CITY OF SEBASTOPOL  
 CITY COUNCIL  
 AGENDA ITEM

**Meeting Date:** March 2, 2021  
**To:** Honorable Mayor and City Councilmembers  
**From:** Kari Svanstrom, Planning Director  
 David Hogan, Contract Planner  
**Subject:** Benedetti Car Wash - Conditional Use Permit, Variance, Tentative Parcel Map, Mitigated Negative Declaration (CEQA)  
**Recommendation:** The Planning Commission recommends that the City Council deny the applications for the Conditional Use Permit, Variance, and Tentative Parcel Map  
**Funding:** Currently Budgeted:  Yes  No  N/A  
 Net General Fund Cost: N/A  
 Amount: \$0

A RESOLUTION OF THE CITY COUNCIL OF THE CITY OF SEBASTOPOL APPROVING THE PLANNING APPLICATIONS FOR THE BENEDETTI CAR WASH PROJECT LOCATED AT 6809 SEBASTOPOL AVENUE (FILE NUMBER 2019-27)

1. Site plan diagram of proposed noise wall location

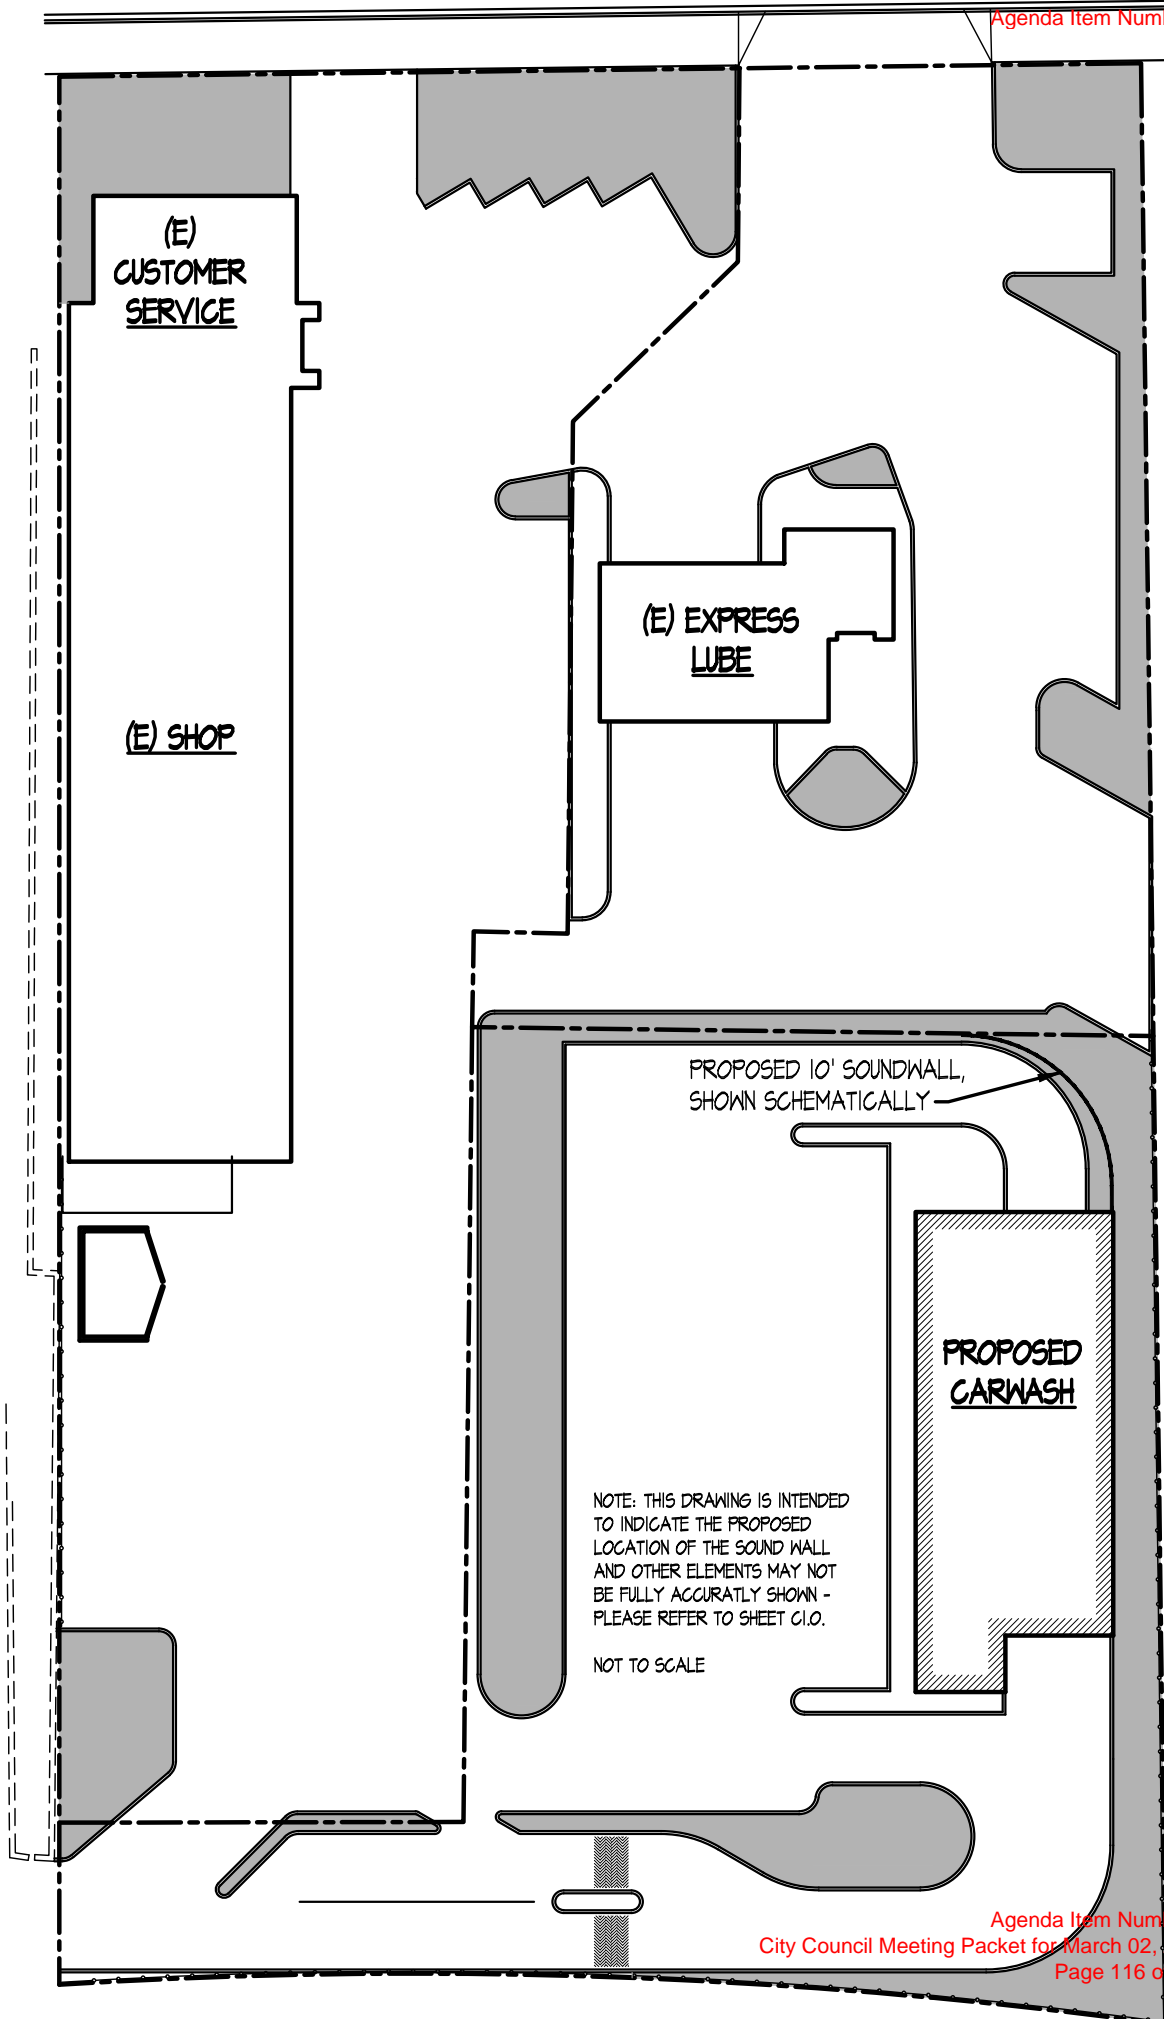
The Council considered the Planning Commission's discussion of the need for an additional sound barrier adjacent to the car wash exit. During the Commission's hearing process, a revised sound wall, 10-feet in height that wrapped around part of the exit drive from the car wash was considered. The purpose of the wall was to deflect noise generated by the car wash away from the adjacent commercial/office building to meet the noise criteria contained in the Municipal Code. The Council wanted this component included in any final project approval and is contained in Condition of Approval #2.b which is proposed to read:

*"The project plans shall incorporate a sound barrier/wall along the east/north side of the car wash exit drive to a point adjacent to the end of the initial segment of the curved exit drive. The noise barrier/wall should be ten feet in height. The noise barrier may include a horizontal cover over the exit from the carwash. The actual length of the wall shall be determined based upon the noise reduction requirements."*

- b. The project plans shall incorporate a sound barrier/wall along the east/north side of the car wash exit drive to a point adjacent to the end of the initial segment of the curved exit drive. The noise barrier/wall should be ten feet in height. The noise barrier may include a horizontal cover over the exit from the carwash. The actual length of the wall shall be determined based upon the noise reduction requirements.

**FIGURE 2 Noise Exposure Resulting from Car Wash Operations – No Silencer**

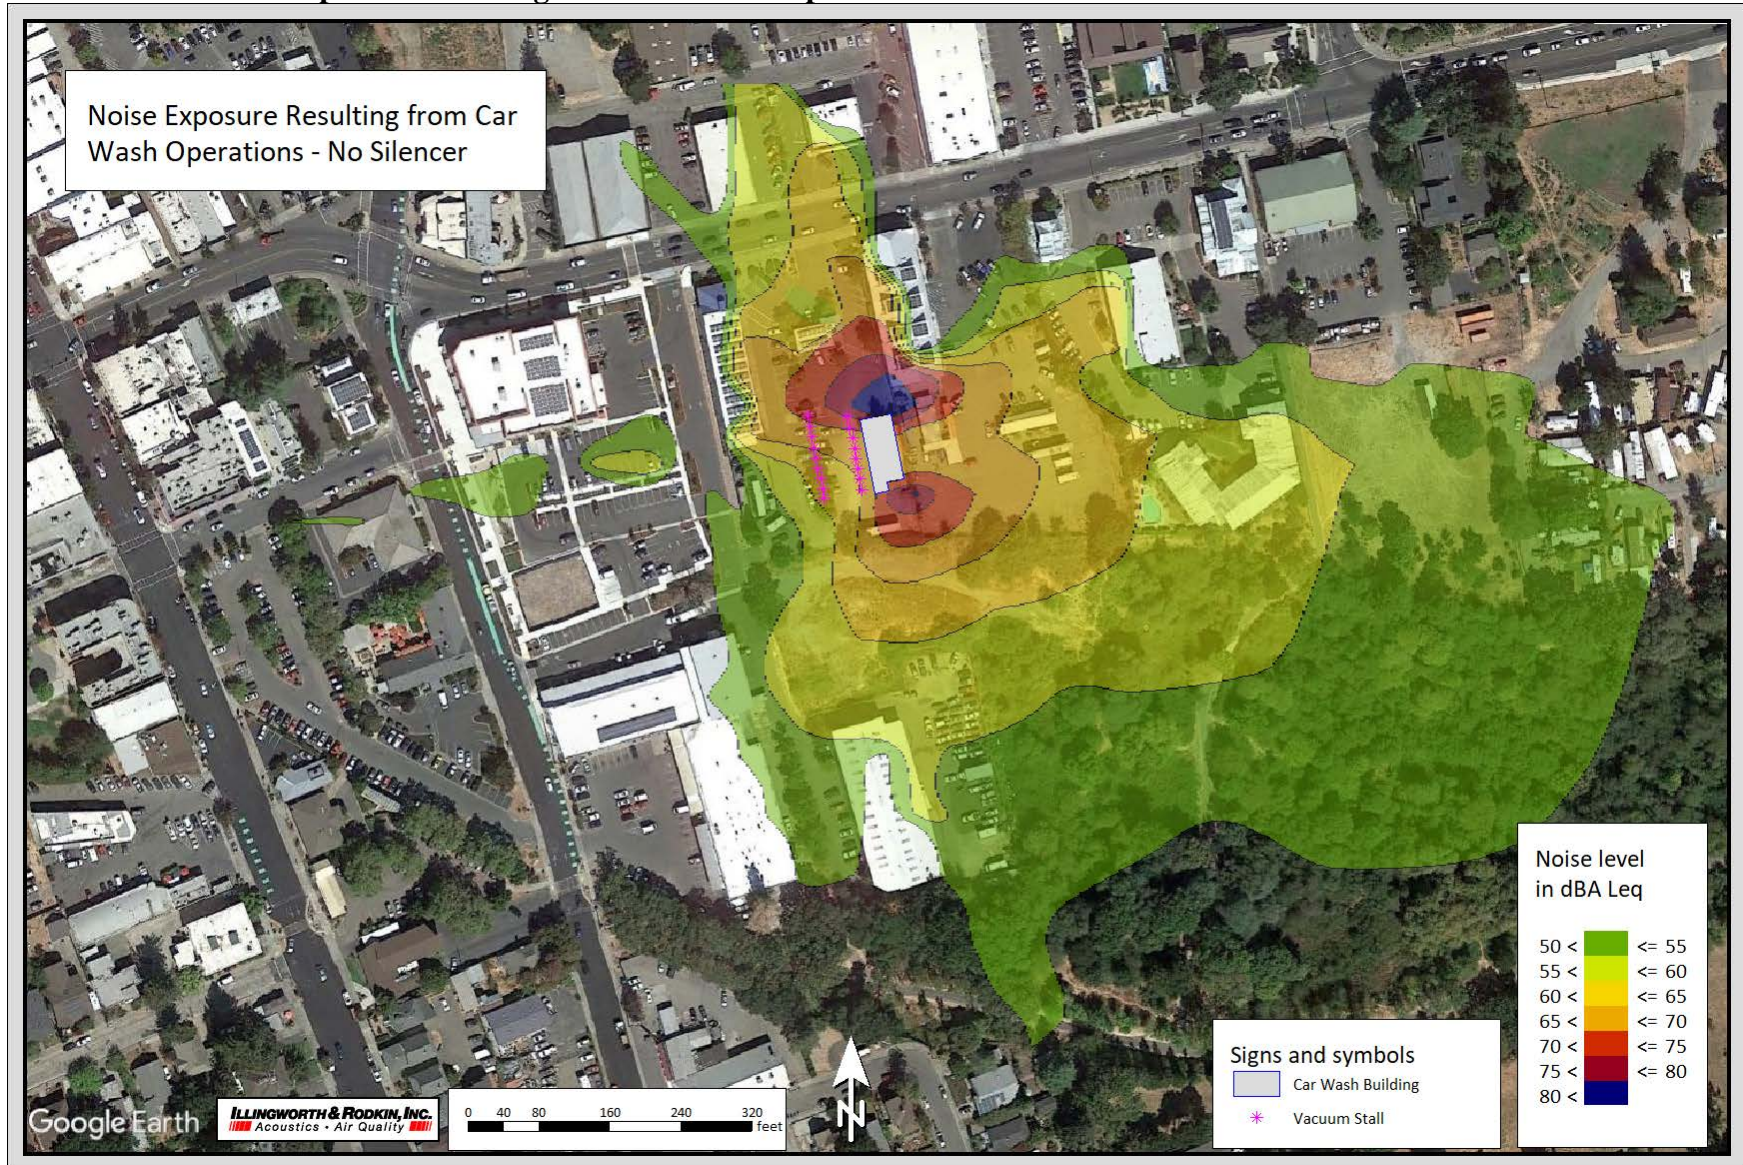
Per Figure 8 of the noise wall analysis, the car wash operation, even with a ten-foot wall, would emit noise between 65-70 dBA onto the adjacent Ford property. I do not understand how a project generating an unlawful noise level can be approved.
